# Wollongong Local Planning Panel Assessment Report | 25 July 2018

<b>WLPP No.</b>	Item 4
<b>DA No.</b>	DA-2017/1196
<b>Proposal</b>	Demolition of existing structures and construction of multi dwelling housing (3 townhouses)
<b>Property</b>	30 Cross Street, CORRIMAL NSW 2518 Lot 10 DP 1054999
<b>Applicant</b>	MMJ Wollongong – Ben McNamara
<b>Responsible Team</b>	Development Assessment and Certification – City Wide Planning Team (JS & VL)

**Figure 4:** Landscaped area

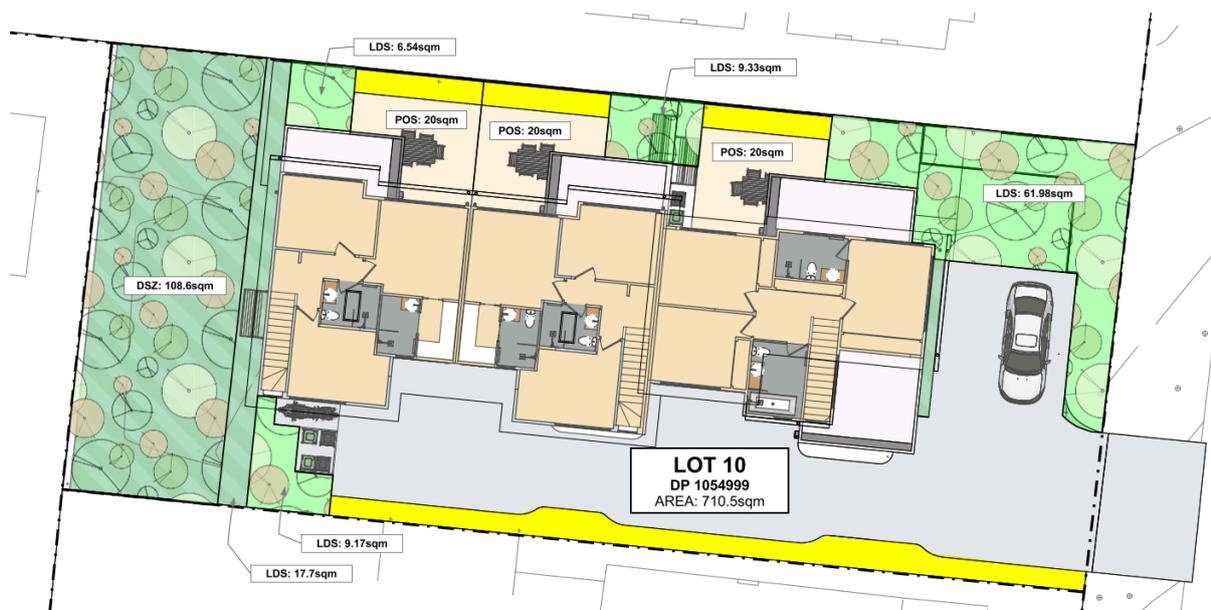
Part 5.8.2.4 requires that the landscaped area must include a 1.5m wide landscaped bed which is provided along the side and rear property boundaries of the site. Part 5(f) of the control also mirrors this control and 5.7 as discussed above and requires that where driveways run parallel to a property boundary, a minimum 1.5m landscape strip is required adjacent to the driveway. The areas in yellow in Figure 4 demonstrate the extent of the area of non-compliance.

b) The extent of the proposed variation and the unique circumstances as to why the variation is requested; and	<p>The extent of the variation is a maximum of 0.9m. The minimum landscaped width proposed is 600mm only on the southern property boundary, and 1m adjoining the POS areas.</p> <p>The variation is requested on the basis that</p> <ul style="list-style-type: none"> <li>• Landscaping is proposed to be provided to all boundaries of the site;</li> <li>• Suitable landscaped strip widths are proposed to allow for suitable planting;</li> <li>• Landscaping provided would be an improvement as there is no established landscaping on the site currently;</li> <li>• It is the applicants' opinion that the development meets the objectives of the control.</li> </ul>

<p>The applicant has indicated that they consider the development consistent with the above objectives.</p> <p><u>Council comment:</u> The development is not considered inconsistent with the above objectives. Councils Landscape Officer has reviewed the proposed landscaping and has advised that subject to recommended conditions, the proposed landscaped strips are sufficient to provide for adequate separation and screening from adjoining properties. Overall the total landscaped and deep soil zone areas meet the minimum development control area requirements across the site.</p>
<p>d) Demonstrate that the development will not have additional adverse impacts as a result of the variation.</p>	<p>The development is not considered to result in unreasonable adverse impacts as a result of the variation. Amendments to the design have been undertaken to increase the landscaped setback to other areas of the site.</p>

<p>Comment: The requested variation has been considered and is capable of support.</p>

**DESCRIPTION**  
Shadow Diagrams:  
9:00am / 10:00am / 11:00am / 12:00pm / 1:00pm / 2:00pm / 3:00pm  
**PAGE SCALE**  
1:250  
**PAGE SIZE**  
A3  
**G-200**

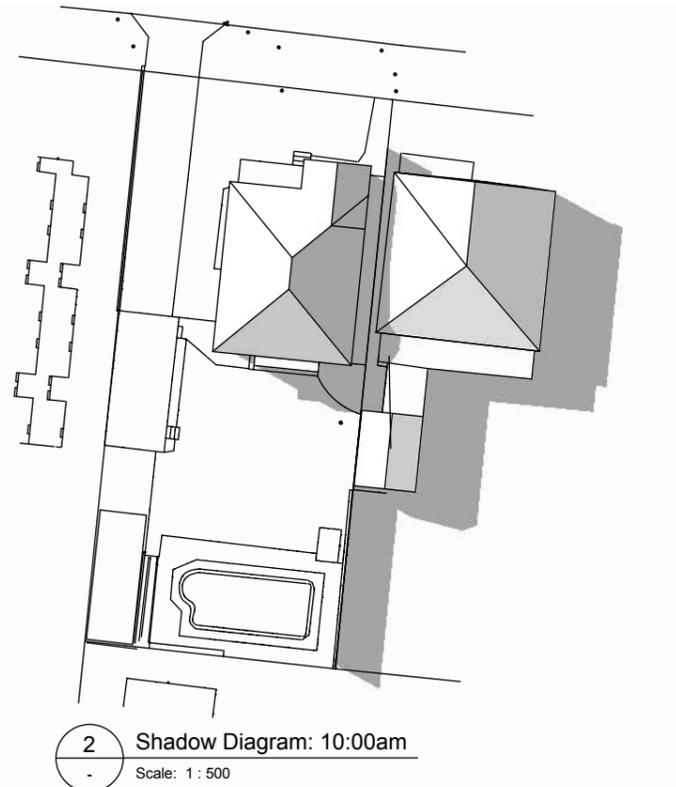
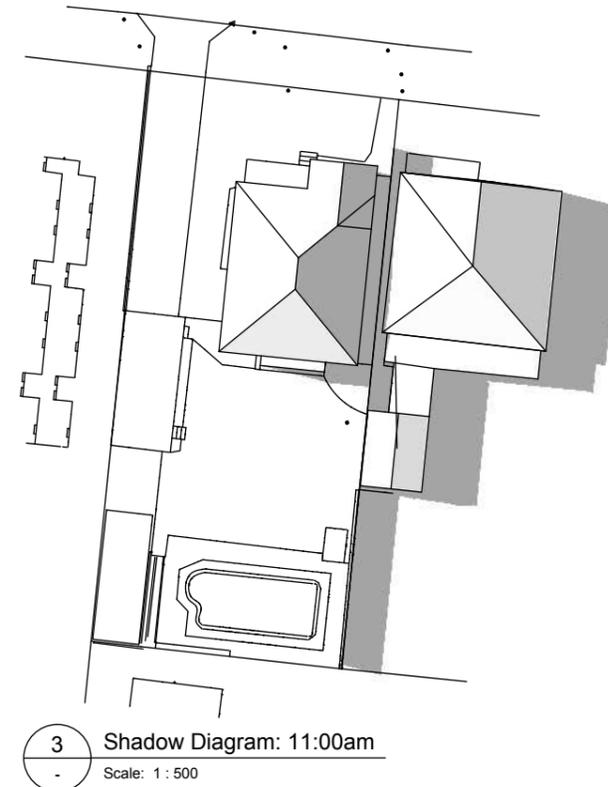
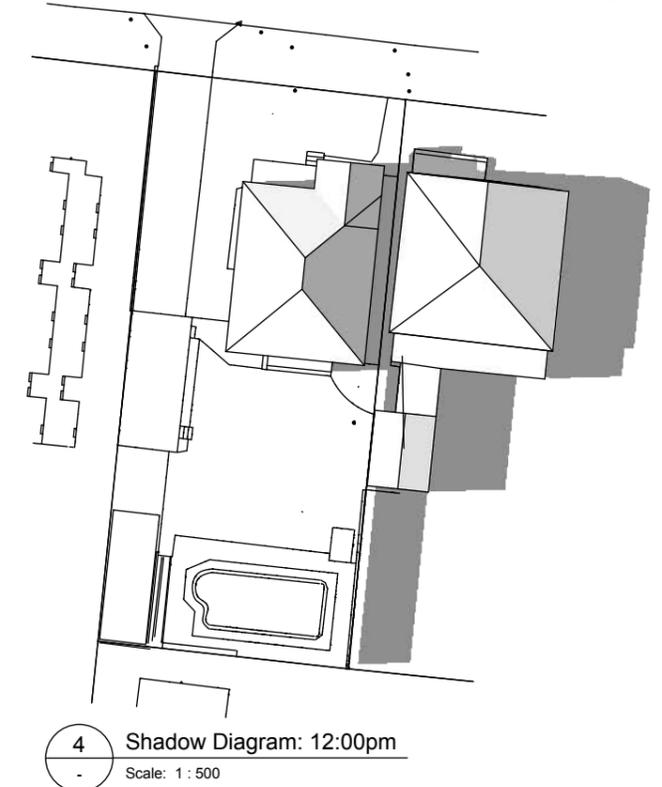
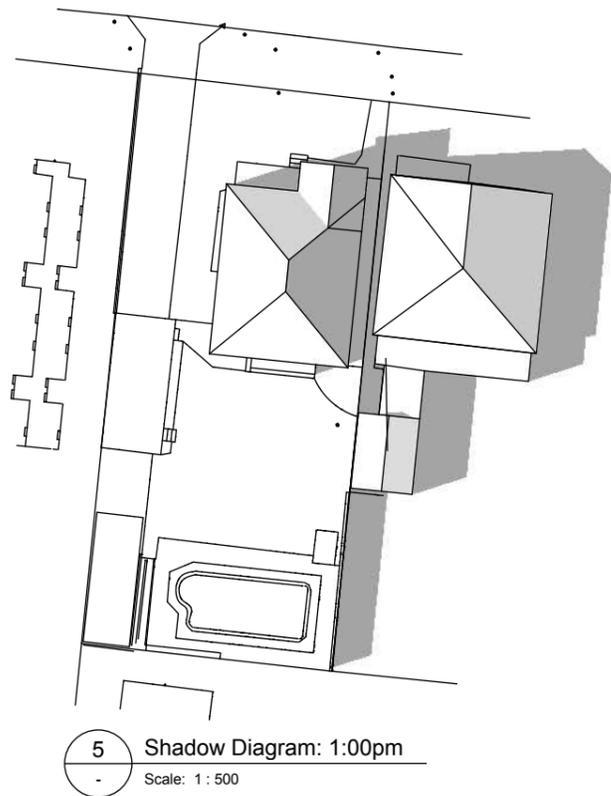
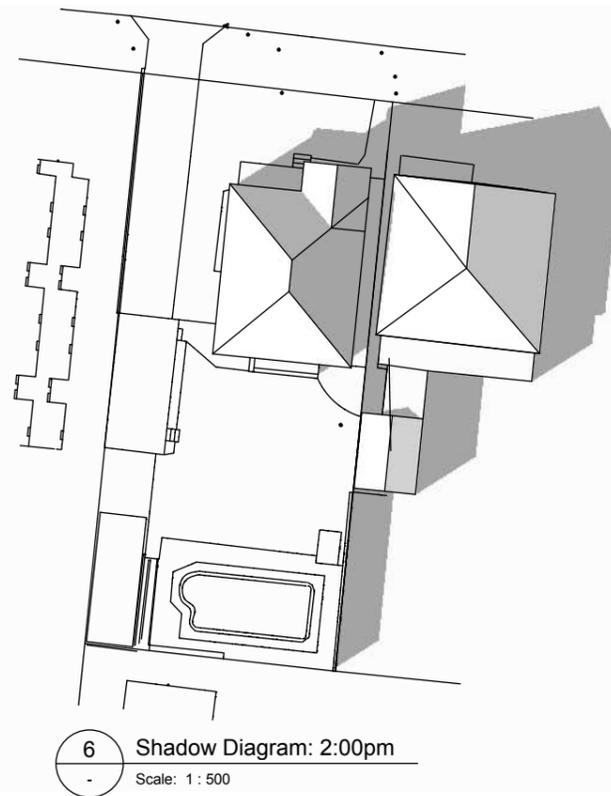
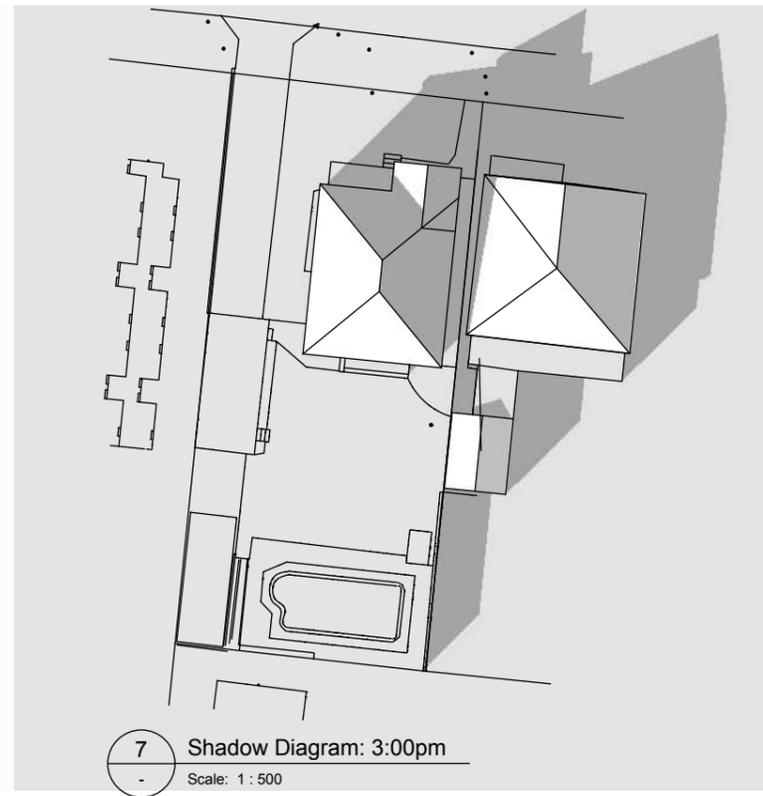
Concern	Comment
sun before 9am which is when an adjoining property receives the majority sunlight.	pursuant to WDCP controls and case law. Shadow diagrams have been provided between 9am and 3pm, in accordance with the development control.
